**RE: Chase Bank - Eubank
340 Eubank NE
Grading and Drainage Plan Stamp Date: 10/6/20
Hydrology File: K21D009C**

Based on the submittal received on 10/12/20, the Grading and Drainage Plan cannot be approved until the following are corrected:

Chase Bank - Eubank
340 Eubank NE
Grading and Drainage Plan Stamp Date: 9/16/20
Hydrology File: K21D009C

Zone Atlas Page:
K-21-Z

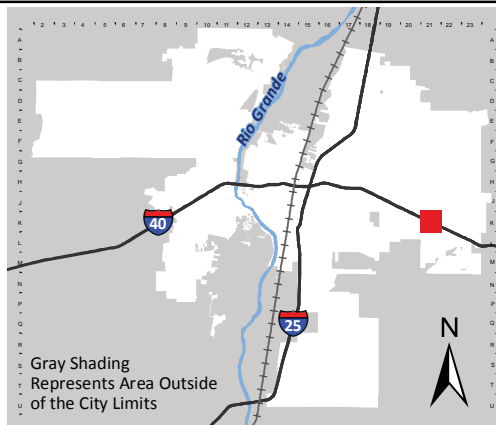
Response: Existing and proposed drainage area calculations provided per the City's Development Process Manual.
2. Please provide a vicinity map showing the location of the site. Typically, this is the Zone Atlas. This can be downloaded in pdf format from the City of Albuquerque's website.

Response: Zone Atlas provided.
3. Provide management onsite for the Stormwater Quality Volume (SWQV) in accordance with the new drainage ordinance, § 14-5-2-6 (H) enacted 10/2/18 (Council Bill C/S O-18-2). To calculate the required volume to be captured, multiply the impervious area (SF) by 0.34 inches for the 90th percentile storm.

PLOT DATE
10/06/20
DRAWING SCALE
1" = 10'
PROJECT NUMBER
CDC20014
SHEET NUMBER
C2.01

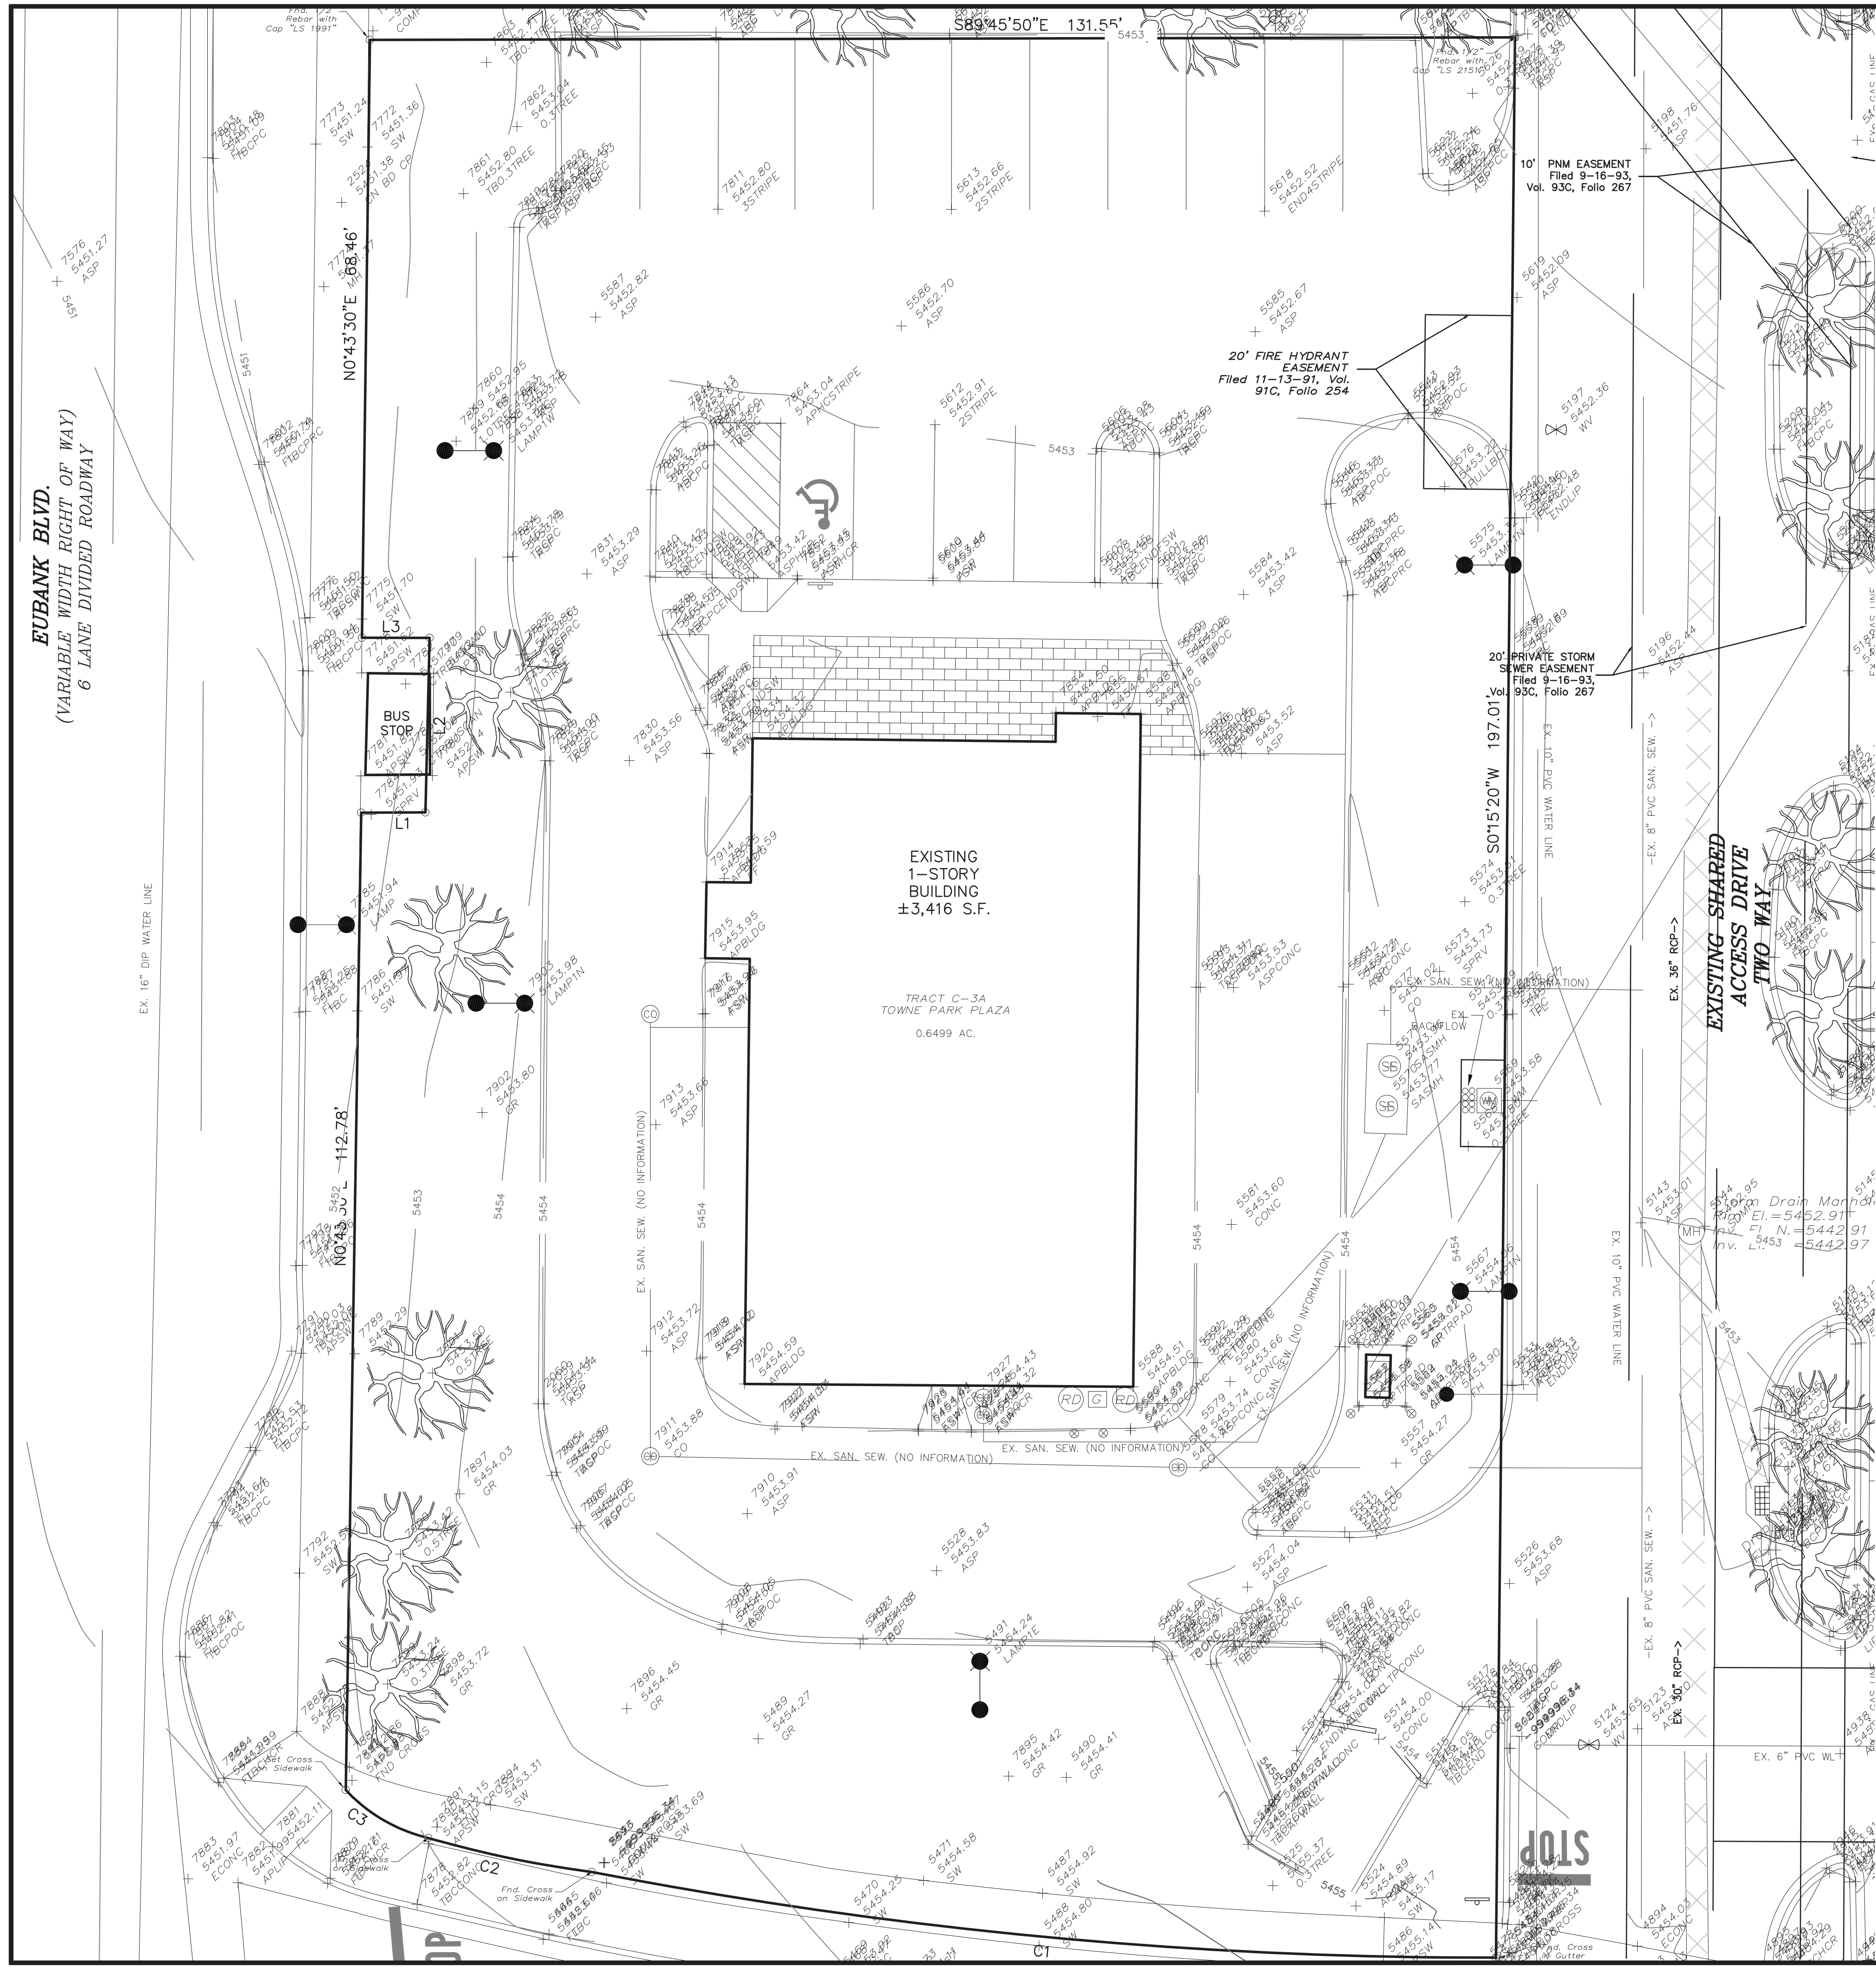
1. Please include your vicinity map on one of your drawing sheets and not as a separate sheet. You do not have to include the entire zone page just the portion showing your site and a reasonable area around. Label it on your drawing as vicinity map and list the zone atlas page. There is plenty of space on the Existing conditions drawing.

2. Sheets C2.01 and C5.01 are too busy. Many of the spot elevations overlap and are unreadable. If information cannot be read it serves no purpose. You can provide contours with more strategically chosen spot elevations to make these drawings cleaner. The survey spots clutter the drawings.

C8.01

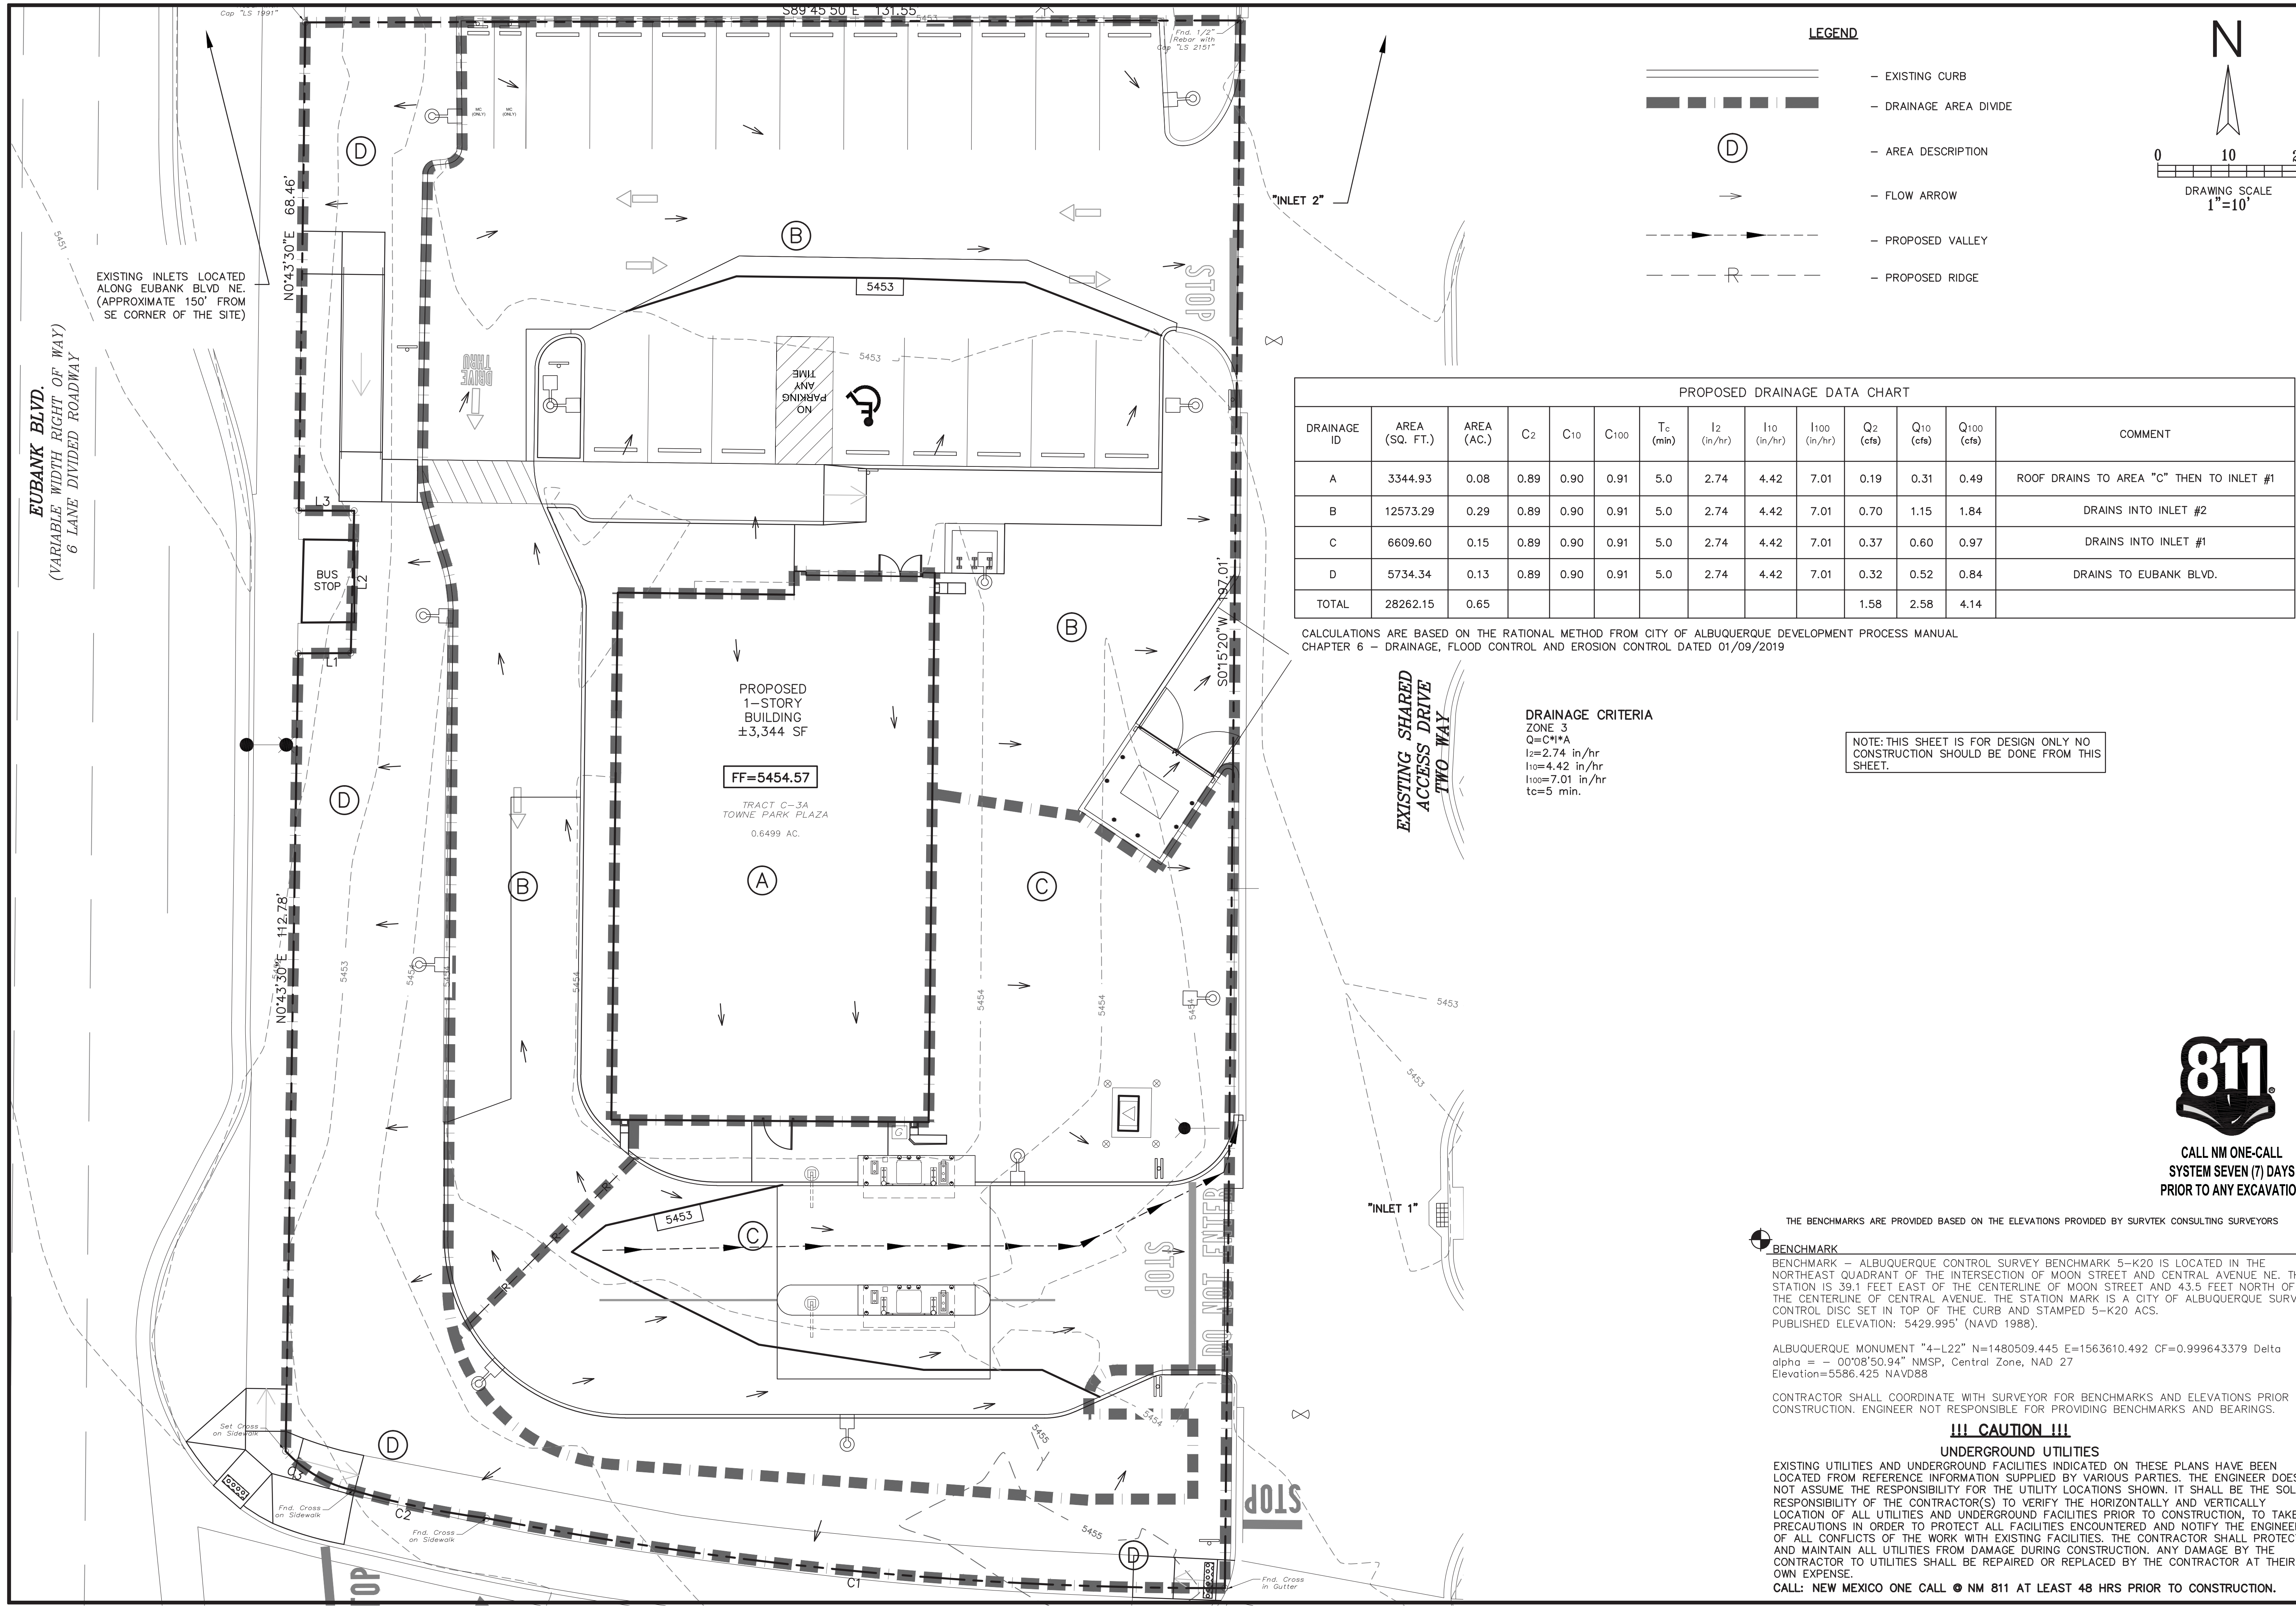
3. Your calculations using the Rational Method outlined in the DPM you used an intensity value I for the 5 minute intensity. We require the 12 minute intensity. What you have calculated is more conservative, but it will affect your Stormwater Quality Volume (see comments below).

4. Please calculate your Qs using all land types not just type D (impervious). What you have calculated is more conservative, but it will affect your Stormwater Quality Volume (see comments below).

5. Please recheck your basin areas. The total area of existing and proposed drainage areas do not match. As you are not adding or subtracting land from your total site these numbers need to match.

6. Please check your drainage calculations for the existing and proposed conditions. In some quick checks some of your Q values are off by 0.01, which is not significant but you may want to recheck to make sure you are comfortable with you values.
